ENGINEERING CHANGE NOTICE NO.

05110

DWG NO. 647.7700

DWG TITLE: STRUT ASSY

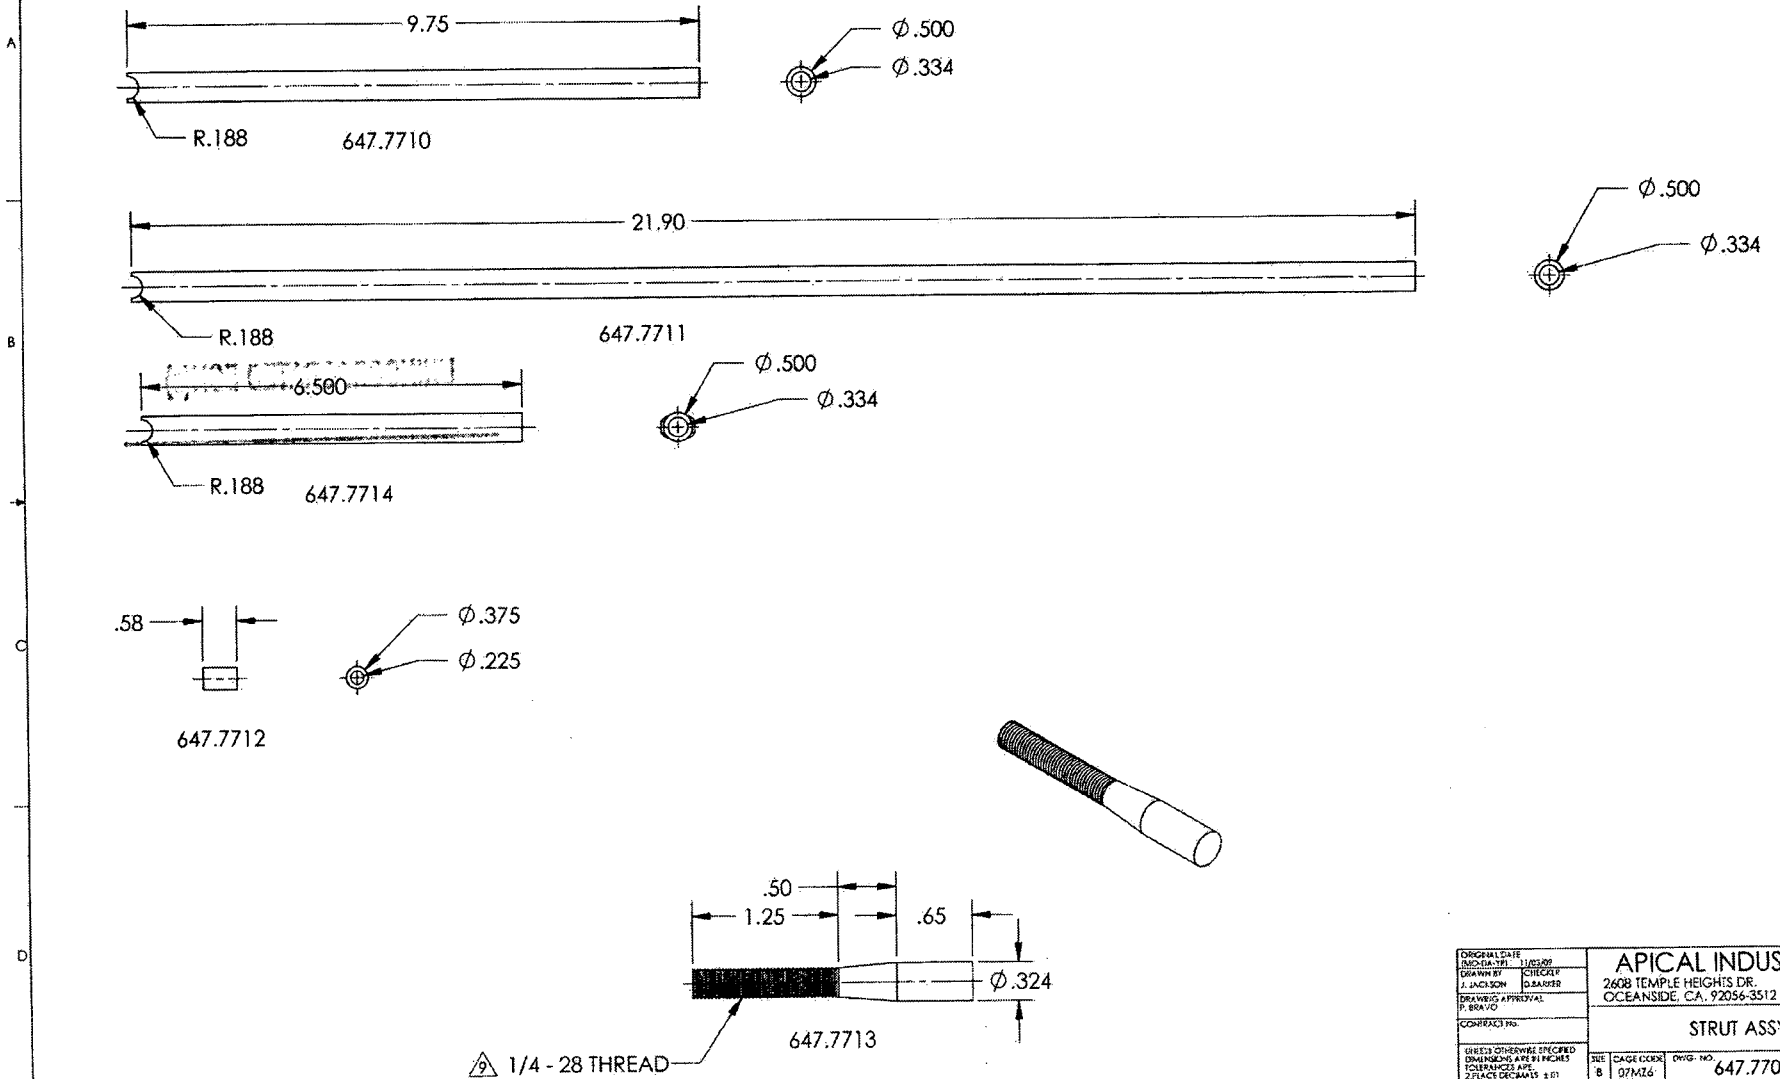
REASON: REVISED FINISH CALLOUT AS PER ECR 15-209

SHEET 1, NOTES IS:

ACTION: UPDATE MO & WO

- 1 MATERIAL: 4130 STEEL PER AMS-T-6736, .50" OD, .083" WALL THK.
- 2 MATERIAL: 4130 STEEL PER AMS-T-6736, .375" OD, .075" WALL THK.
- 3 MATERIAL: 4130 STEEL PER AMS-T-6736, .324" OD.
- 4 FINISH: PRIME IAW MIL-P-2337J TYPE I CLASS N; 1-2 MIL MAX
5. DEBURR AND BREAK ALL SHARP EDGES
6. IDENTIFY IAW MPP-120.
- 7 WELD IAW MIL-STD-2219. TIG WELD WITH FILLER ROD
- 8 FINISH: CAD PLATE IAW QQ-P-416F CLASS I TYPE II
- 9 MASK THREAD PRIOR TO FINISH
